UNITED STATES  
DEPARTMENT OF THE INTERIOR  
BUREAU OF LAND MANAGEMENTFORM APPROVED  
OMB NO. 1004-0137  
Expires: January 31, 2018**SUNDRY NOTICES AND REPORTS ON WELLS**  
*Do not use this form for proposals to drill or to re-enter an abandoned well. Use form 3160-3 (APD) for such proposals.***SUBMIT IN TRIPLICATE - Other instructions on page 2**

Dugan Production Corp. plans to plug and abandon the well as per the following procedure:

Re: Permanent Abandonment  
Well: Lee's Ferry #90

CONDITIONS OF APPROVAL

### Planned P & A Wellbore Schematic

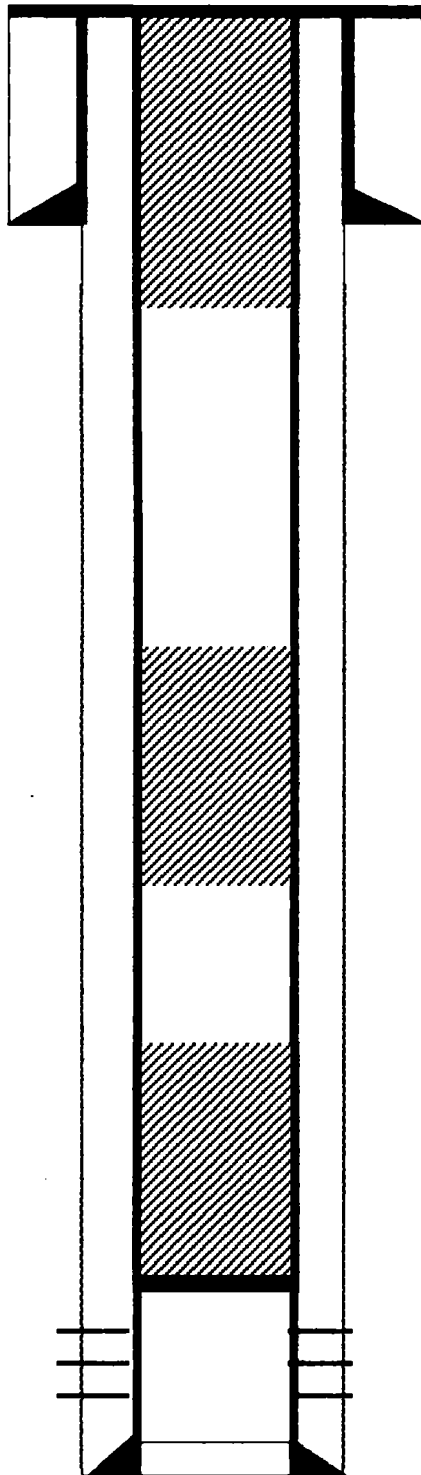
**\*\* BLM REVISED \*\* BLM REVISED \*\* BLM REVISED \*\* BLM REVISED \*\* BLM REVISED \*\*****NMOCD**

1294 - 1580

1344

- a) Set Plug #1 (1580'-1294') ft. To cover the top of Fruitland top. BLM picks top of Fruitland at 1344 ft.
